**GULF STATES UTILITIES COMPANY**

River Bend Station Unit 1  
Docket No. 50-458

Enclosed for your review are Gulf States Utilities Company (GSU) responses to Request for Additional Information identified by the Nuclear Regulatory Commission's Power Systems Branch (PSB). This letter supplements information contained in docketed correspondence from J. E. Booker to H. R. Denton dated December 30, 1983 and February 10, 1984. Attachment 1 of this letter summarizes the Staff request identified in meeting between GSU and PSB dated February 15, 1984. The following enclosures contain the actual written changes to the FSAR text including all tables and figures. These changes will be incorporated into the FSAR in a future amendment.

## ATTACHMENT 1

ENCLOSURE 5

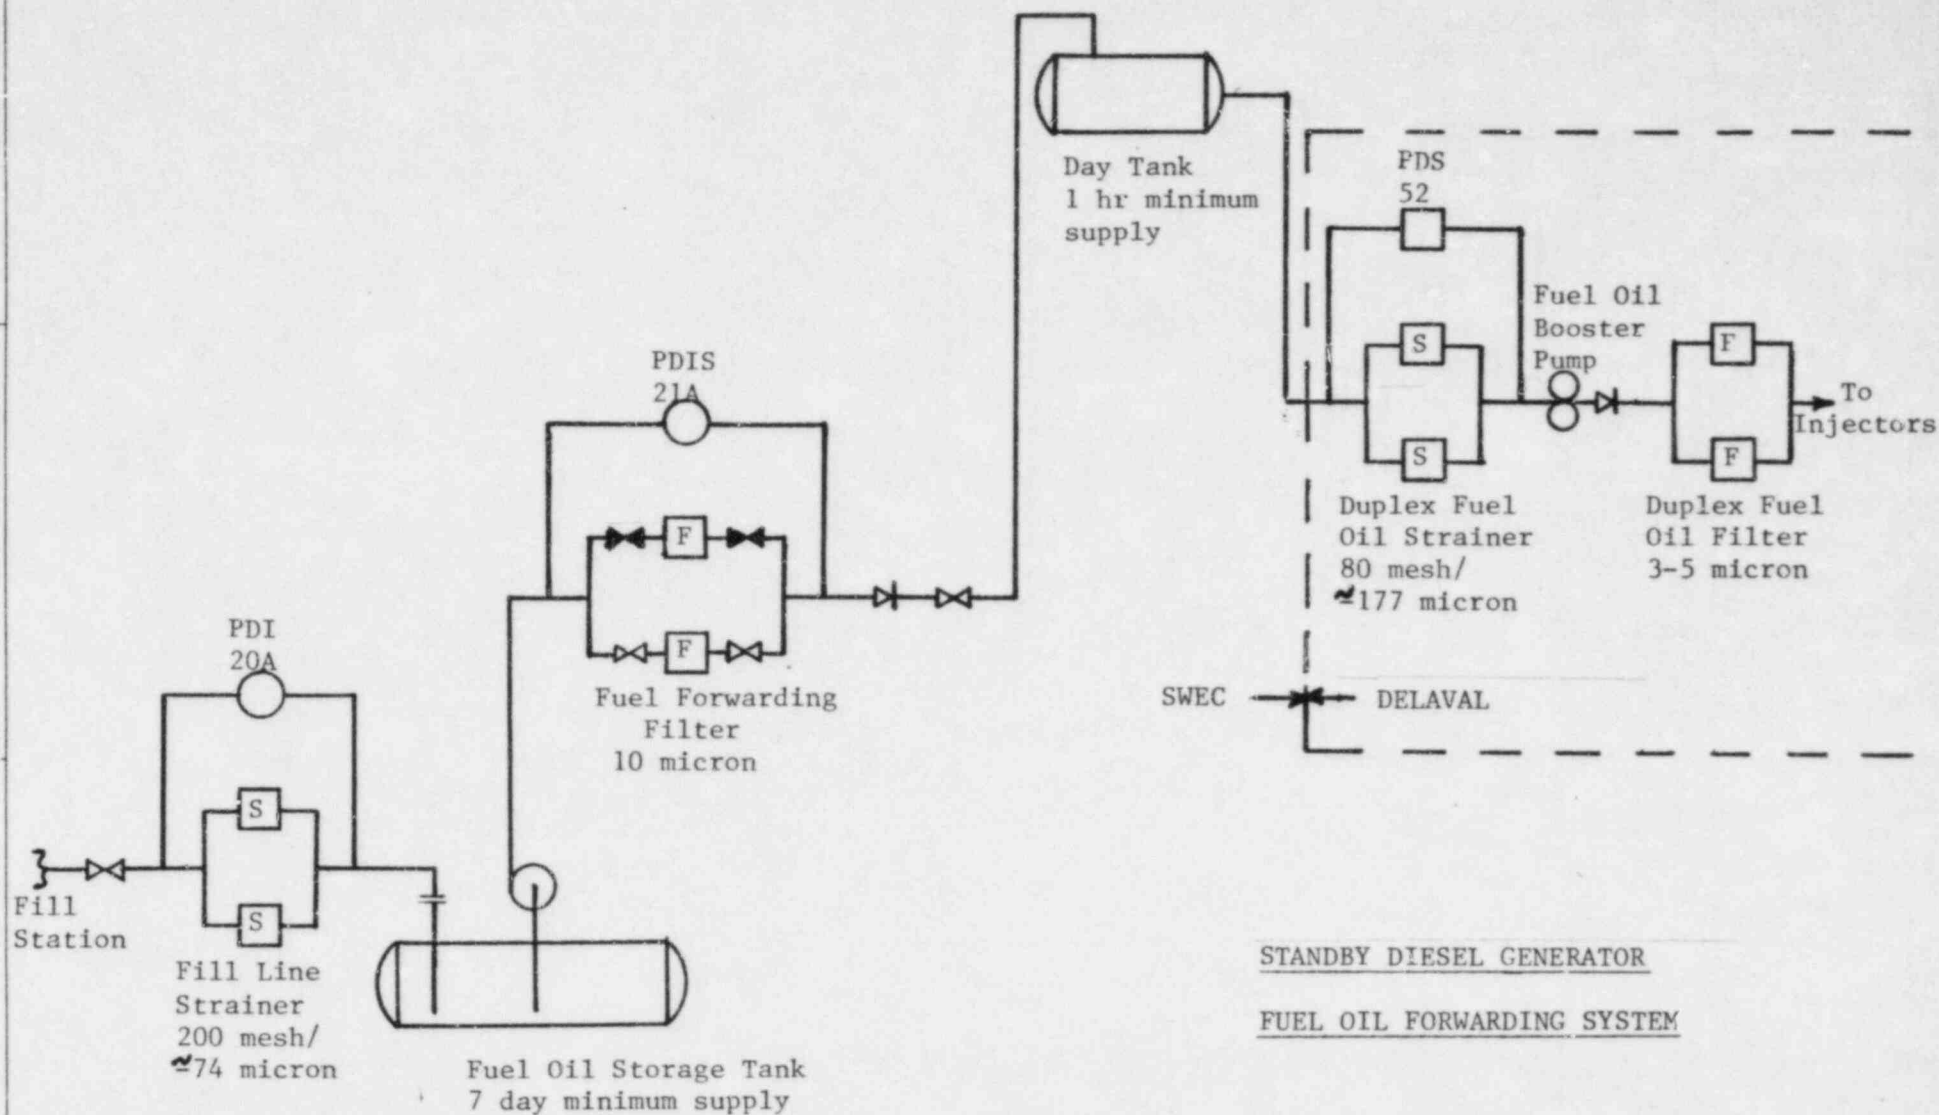
5. Fuel Oil Storage Tank Sediment - The response to this request is provided in Enclosure 4. In addition, a drawing has been provided as Enclosure 5 for your information describing the location and size of filters between the fuel oil storage tank and the diesel generator.

The fuel oil forwarding filters described in Section 9.5.4.2.3 are designed to remove any sediment that might be stirred up during refueling.

FIGURE 9.5-4a

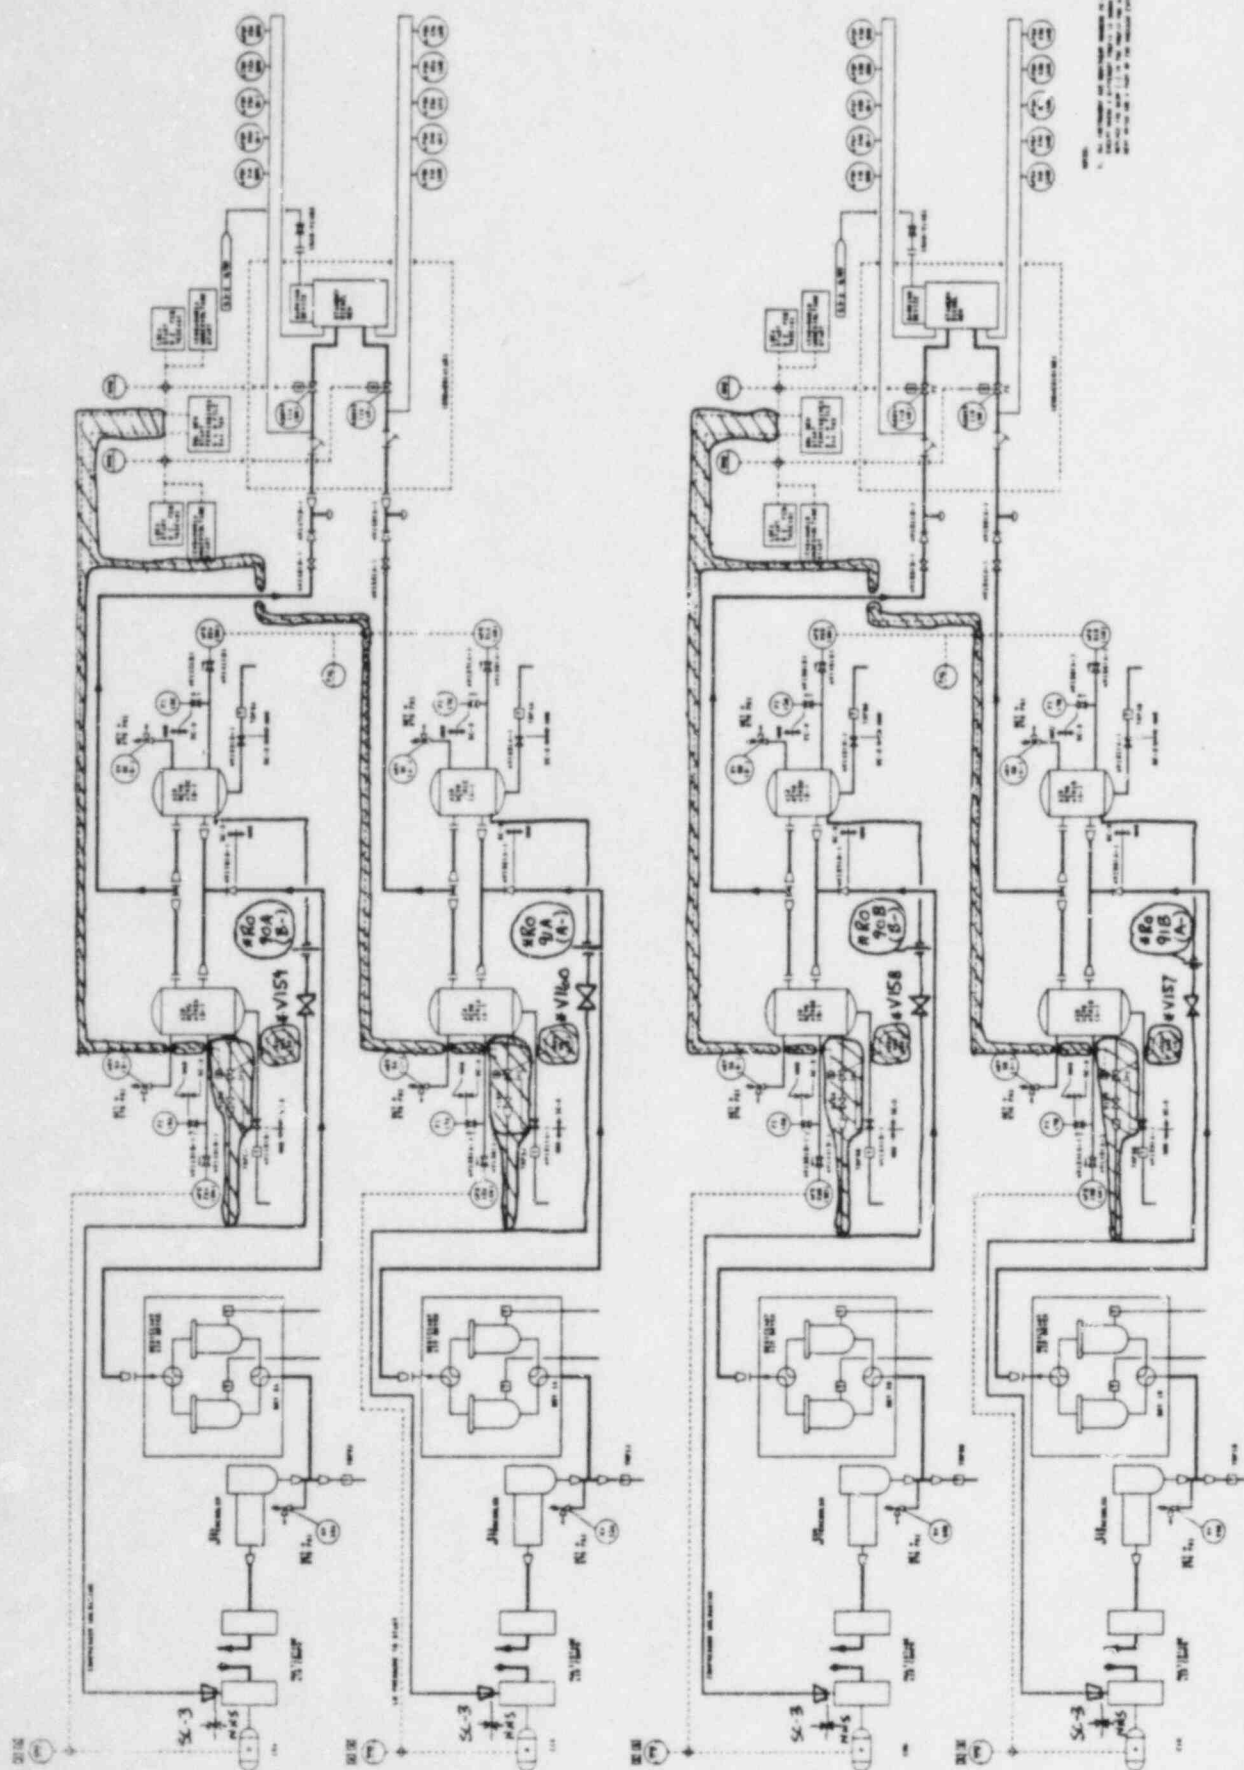
The compressed air is dehydrated by a non-cycling refrigerated-type dryer. The dryers are complete with hermetic refrigeration system, self regulating hot gas bypass valve, chiller section and separator. The dryers maximum operating pressure is 300 psig. Dehydrators are capable of producing a constant pressure dew point of 35°F. Dryers have an capacity of 500 scfm when dehydrating at 100 psig with 100°F saturated inlet air temperature at 110°F ambient temperature to obtain a 35°F outlet dew point.

freshly regenerated desiccant. The air dryer reduces the air starting dew point to  $-40^{\circ}\text{F}$  at 250 psig. The prefilter removes entrained water and oil from the air entering the air dryer, and the air filter removes any desiccant which may become airborne during drying.

Fig. 1A System Schematic Diagram, "S" Units  
UNMODIFIED

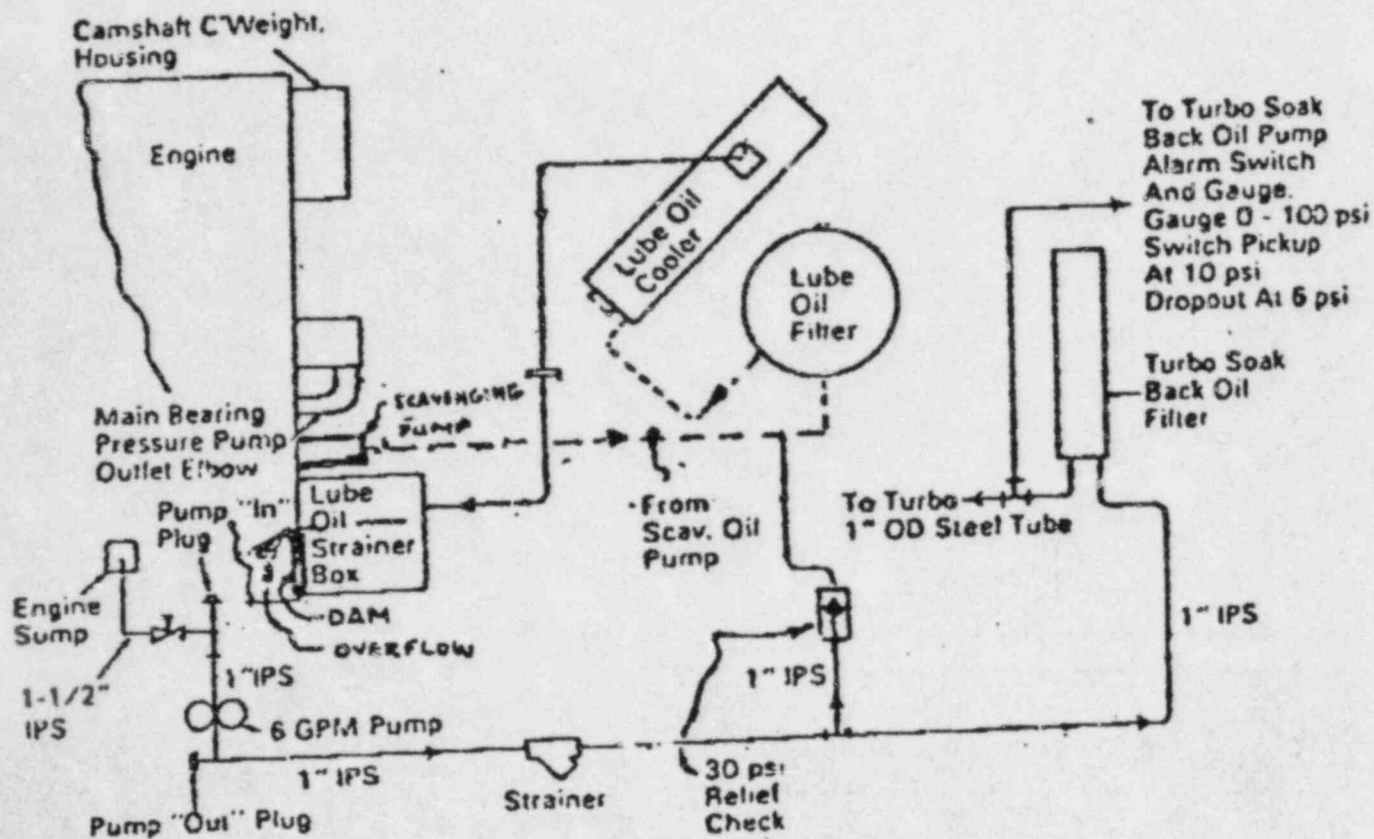
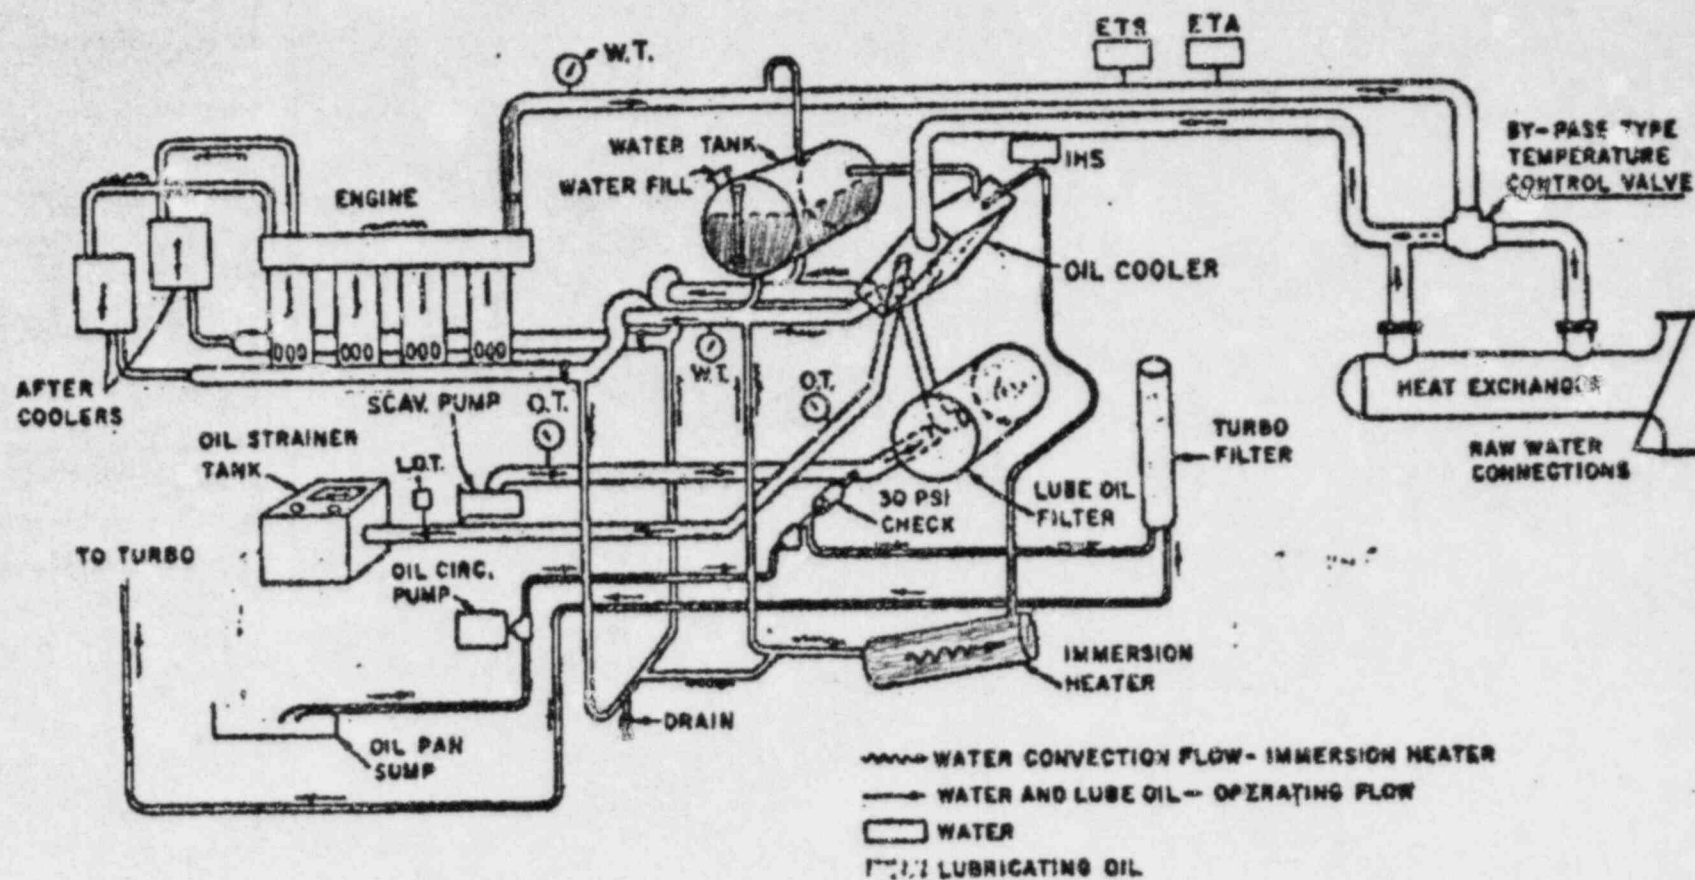
The HPCS lube oil system piping and connections will be modified to implement diesel manufacturer's recommendation MI-9644. Lube oil flows to the preheat system and to the turbocharger will be separated. The AC motor driven circulating pump will provide 6 gpm flow to the preheat system and the VDC motor driven soakback pump will provide 3 gpm flow to the turbocharger. Both of these pumps will have the capability to operate continuously. Vent lines with orifices will be added to the lube oil filter and lube oil cooler to bleed off any entrapped air and the vents will be connected to the engine camshaft housing to discharge any oil flows back to the engine. A vent will also be added to the lube oil cooler discharge pipe to prevent a syphon effect that would draw oil out of the cooler into the engine strainer box. Two new sight glasses will be added for visual monitoring of the oil level during standby.

2. Figure 1B schematically shows the EMD modification per MI 9644 designed to overcome the conditions in 1(b-2).

- (b) Vents with orifices were added to the lube oil filter and lube oil cooler to bleed off entrapped air and the vents were connected to the engine camshaft housing and discharged whatever oil flowed back into the engine. A vent was also added to the lube oil cooler discharge pipe to prevent a syphon effect that would draw oil out of the cooler into the strainer.
- (c) Another improvement is to flood the main oil gallery which supplies oil to the main bearing, the accessory drive, the turbo and the top deck. This would also minimize the time for oil to reach these components during a fast start as well as maintain lubrication of the main bearings.

FIGURE 9.5-5b

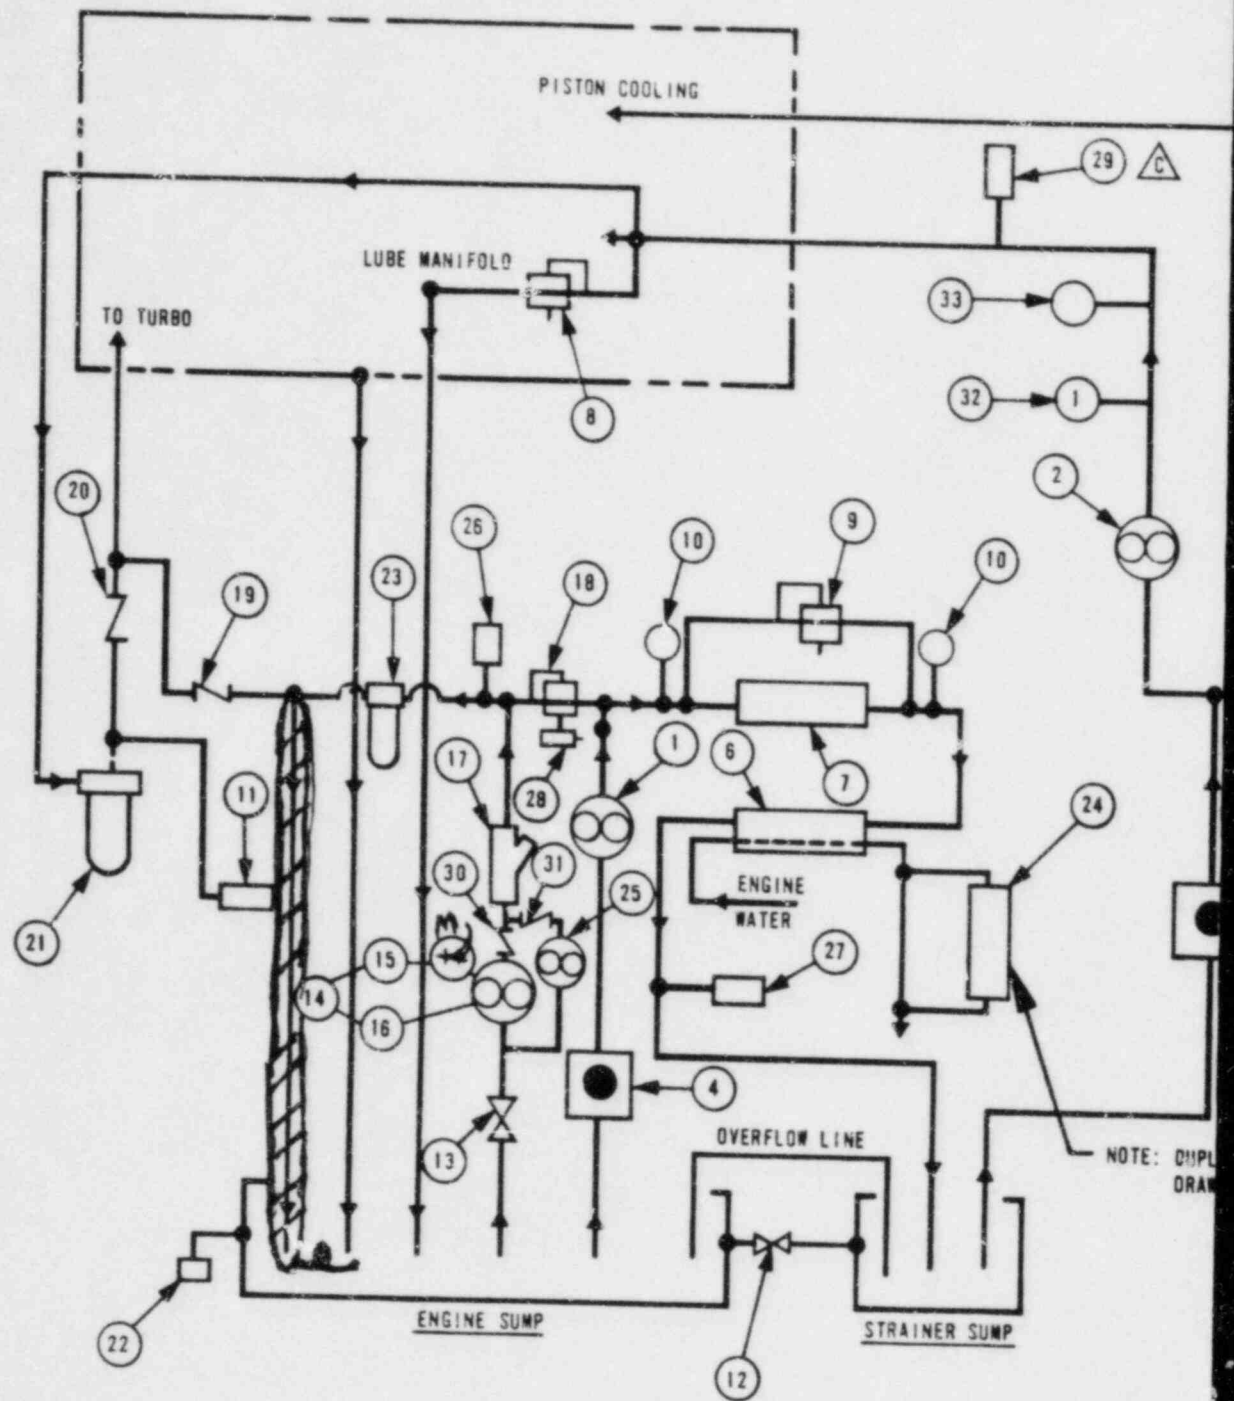
QUESTION 430.101 (9.5.7)

The response to this request is provided in revised Section 9.5.7.2 and Fig. 9.5-5b. | 5
